## 15E ATWS Performance Evaluation

The information in this appendix of the reference ABWR DCD, including all subsections, tables, and figures, is incorporated by reference with the following departures.

STD DEP T1 3.4-1 (Figures 15E-1a, 15E-1b, 15E-1c)

Figure 15E-1a ATWS Mitigation Logic (ARI, FMCRD Run-In, RPT, Manual Initiation)

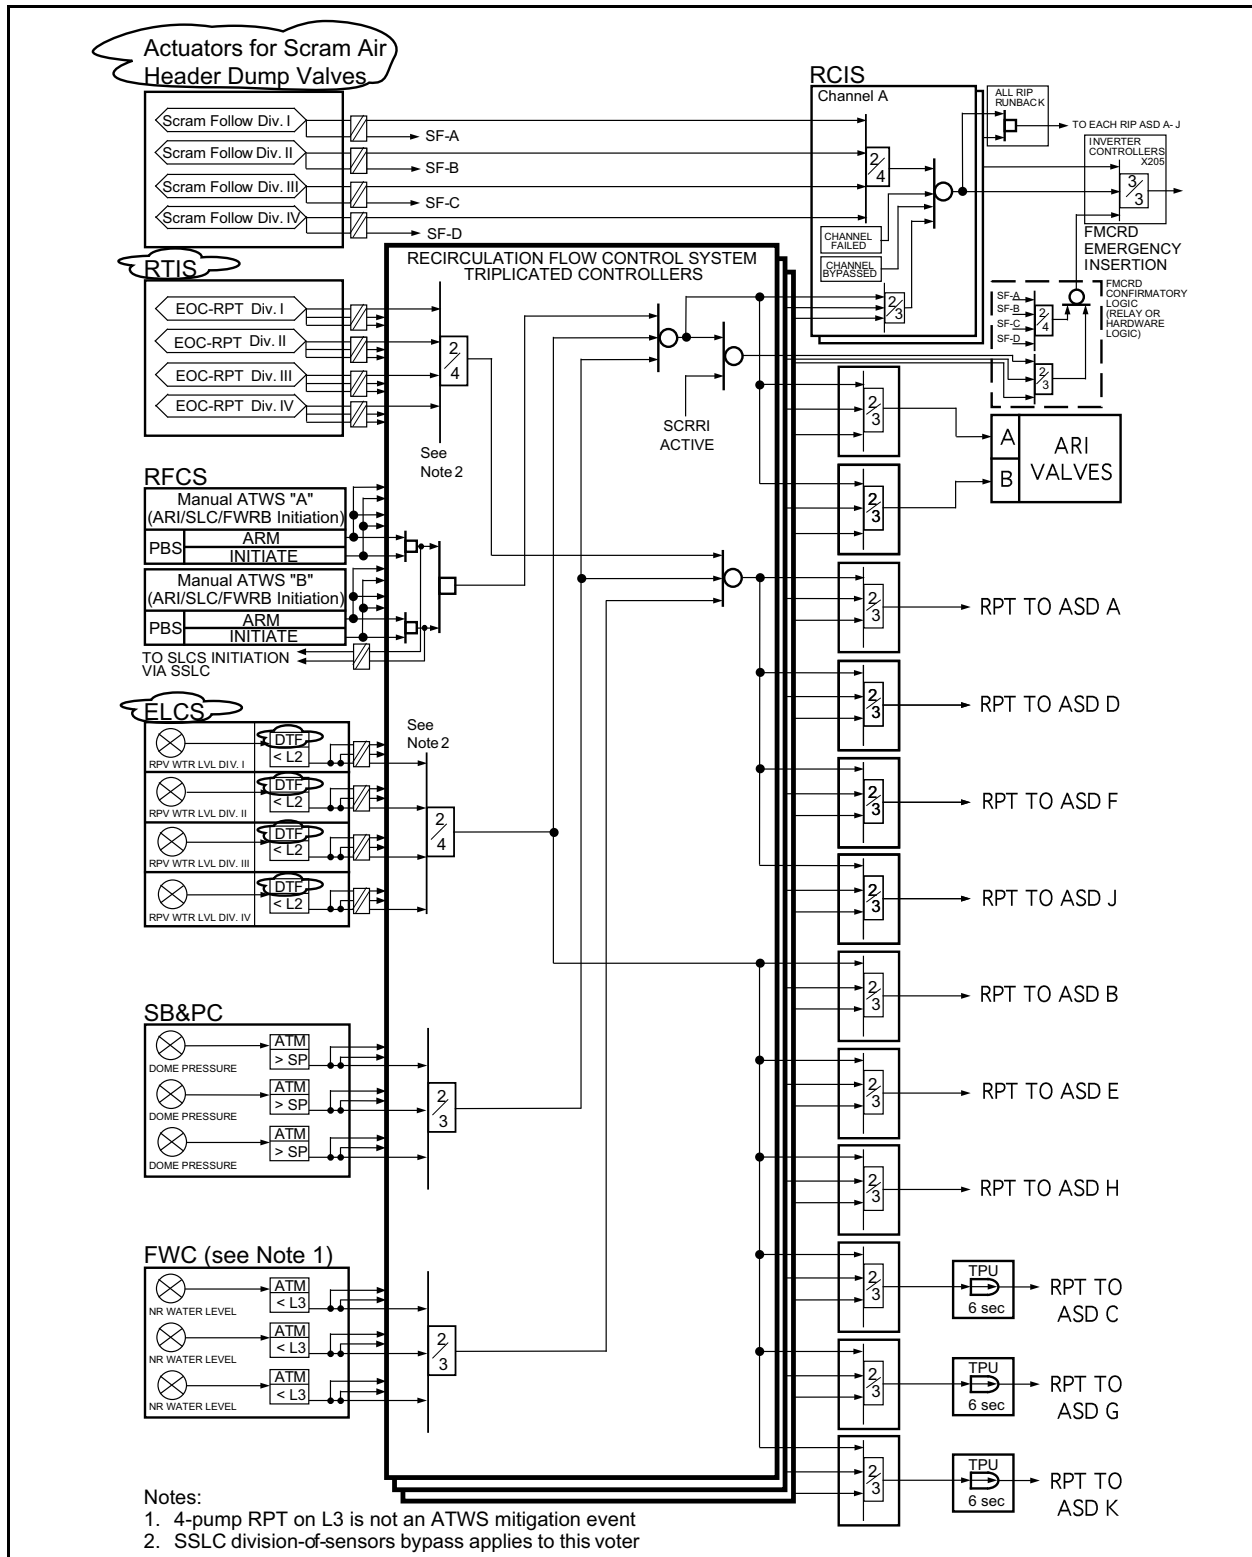
*The mitigation of ATWS events is accomplished by a multitude of equipment and procedures. These include ARI, FMCRD run-in, feedwater runback, RPT, recirculation runback, ADS inhibit, and SLCS. The logic of this ATWS mitigation is presented in Figures 15E-1a, 15E-1b and 15E-1c. The following are the initiation signals and setpoints for the above response:*

Figure 15E-1c ATWS Mitigation Logic (SLCS Initiation, Feedwater Runback)

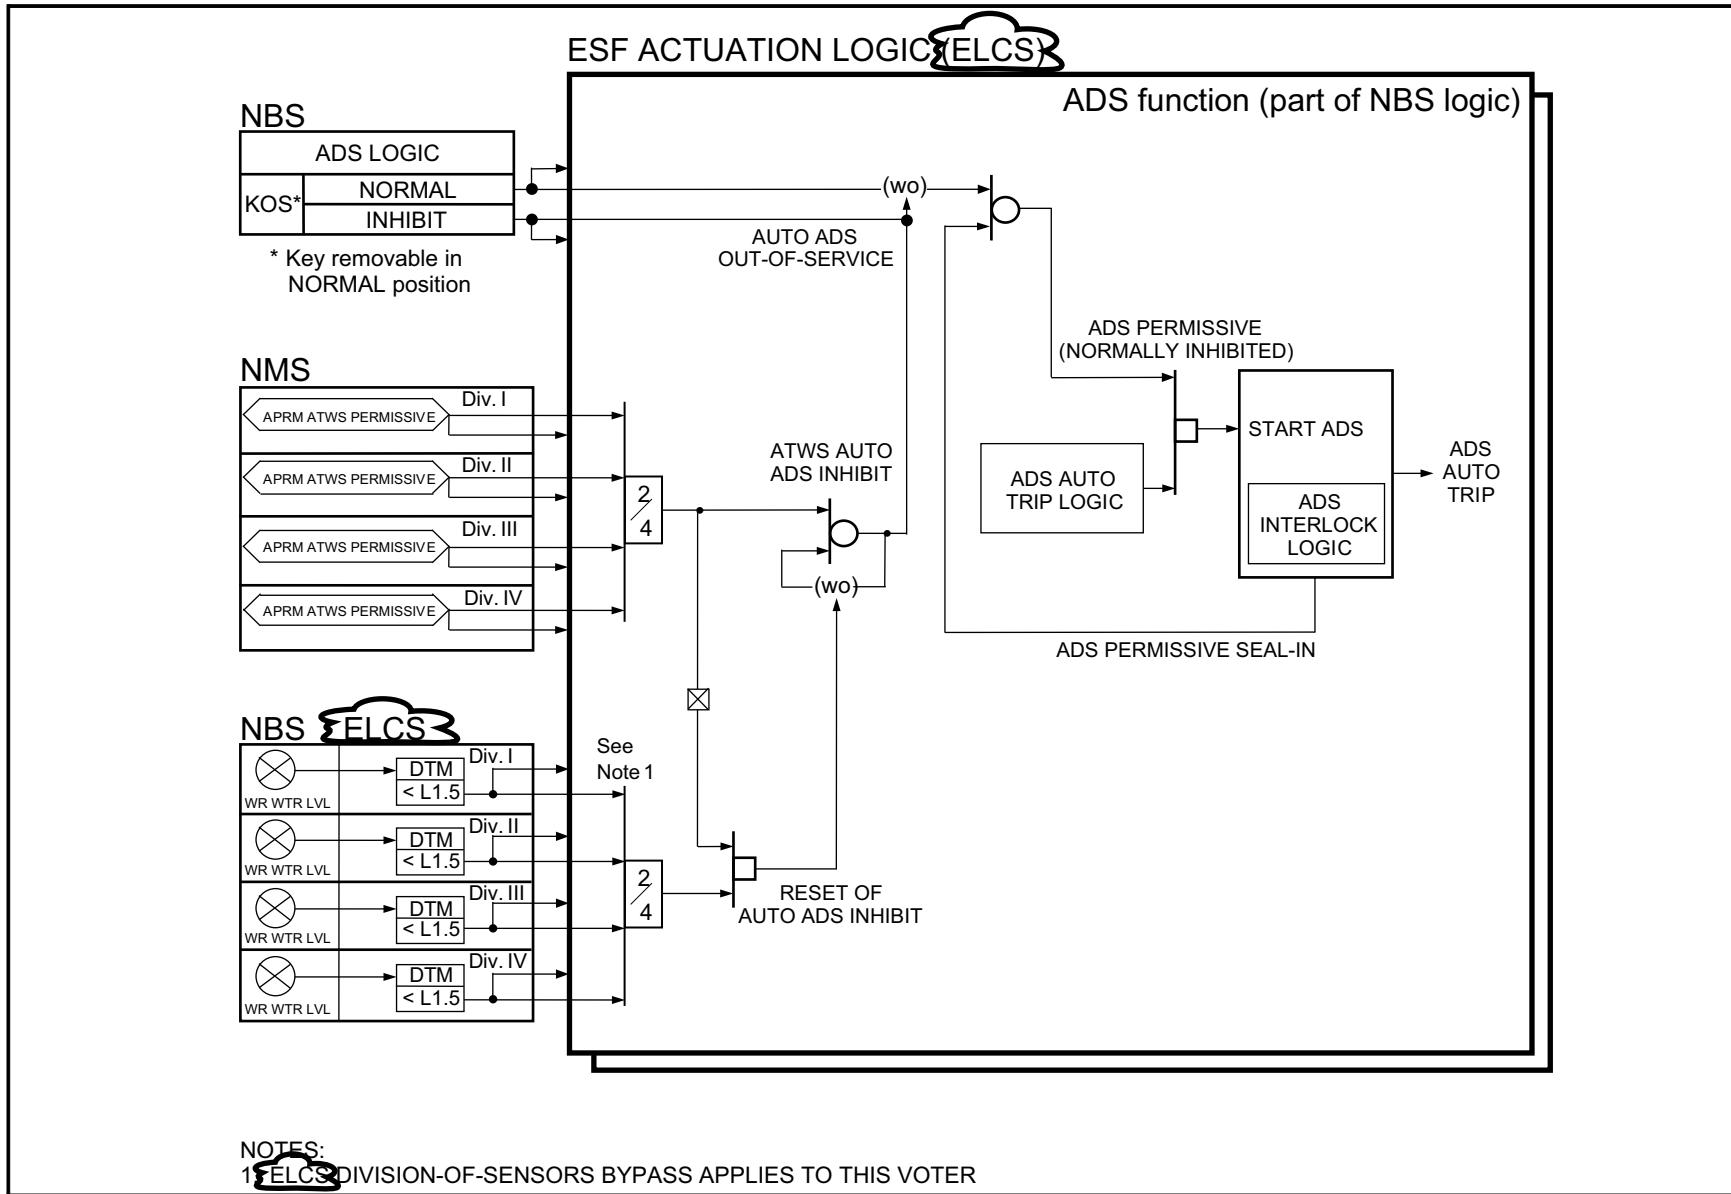
- *Automated initiation of ADS is inhibited ~~unless there is a coincident low reactor water level signal (level 1.5) and an APRM ATWS permissive signal~~ whenever potential ATWS conditions exist as indicated by APRMs not being downscale.*
